# ***Nomad*** **SERVICE BULLETIN**

Reference No 233

**TRANSMITTAL LETTER  
FOR  
SERVICE BULLETIN NMD-55-29**

**STABILISERS — HORIZONTAL STABILISER — PIVOT BRACKET BUSH REWORK**

**Figure 1 Horizontal Stabiliser Attachment Brackets - Modification to Bushes**

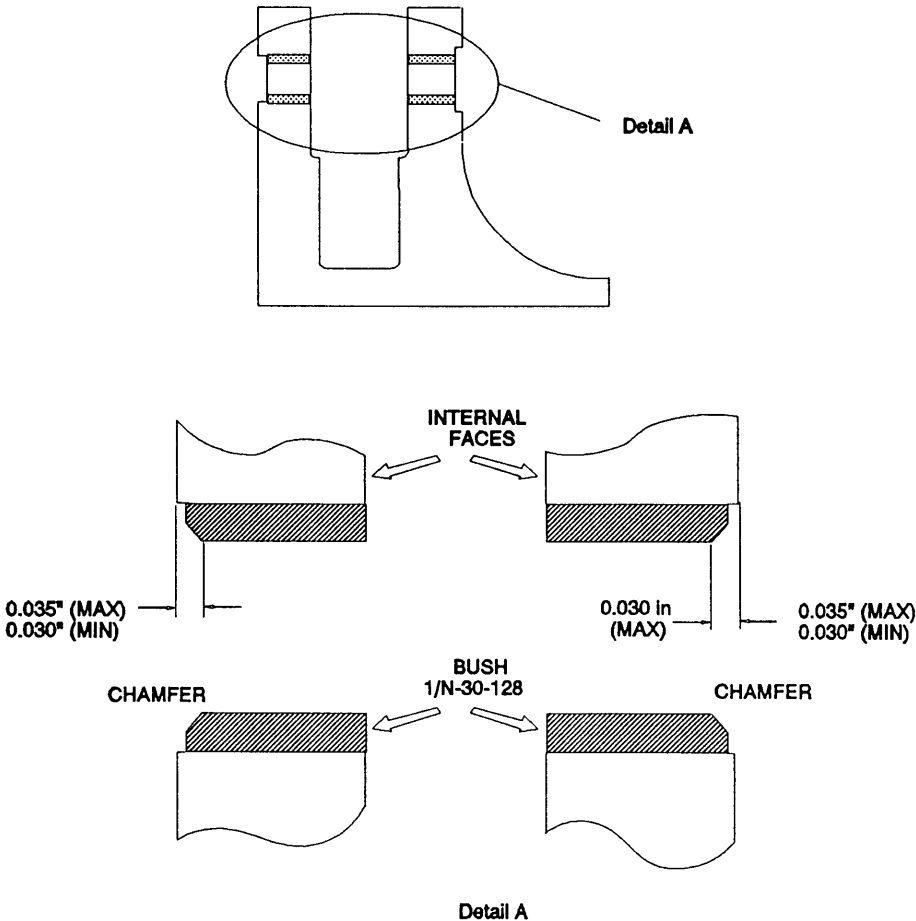
- (1) The internal faces of Pivot Bracket Bush PN 1/N-30-128 are to be inspected and, if necessary, pressed flush with the lugs of Pivot Bracket PN 1/N-30-127.
- (2) The external faces of Bush PN 1/N-30-128 are to be chamfered to allow the bolt head to seat properly.

A. Inspect Bushes PN 1/N-30-128 to determine whether the internal faces are flush with the internal faces of Pivot Bracket PN 1/N-30-127 (Ref Fig 1). If bushes are flush, proceed to step B. If not, proceed as follows:

B. Use a 90° angle countersink tool or countersink mini-grinder in a suitable hand tool to remove up to 0.030/0.035 in of material in accordance with Figure 1.

**Figure 2 Method For Pressing Bushes Flush With Pivot Bracket**

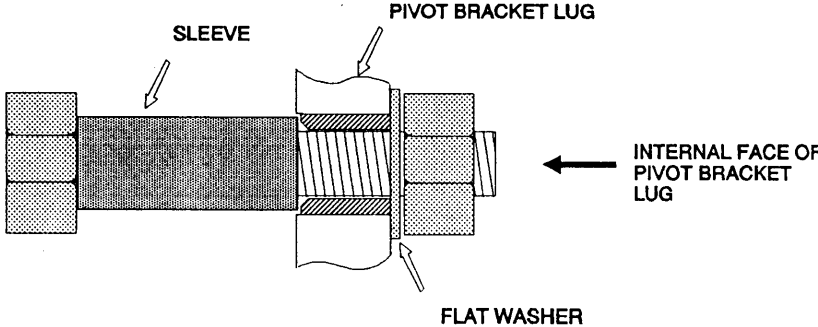
- (1) Assemble Pivot Bolt PN 2/N-00-44, a sleeve of suitable length and diameter slightly less than that of the bush and a large flat washer to the pivot bracket as shown in Figure 2.
- (2) Slowly tighten nut until the internal faces of the bush and lug are flush.
- (3) Repeat for remaining bushes as required.
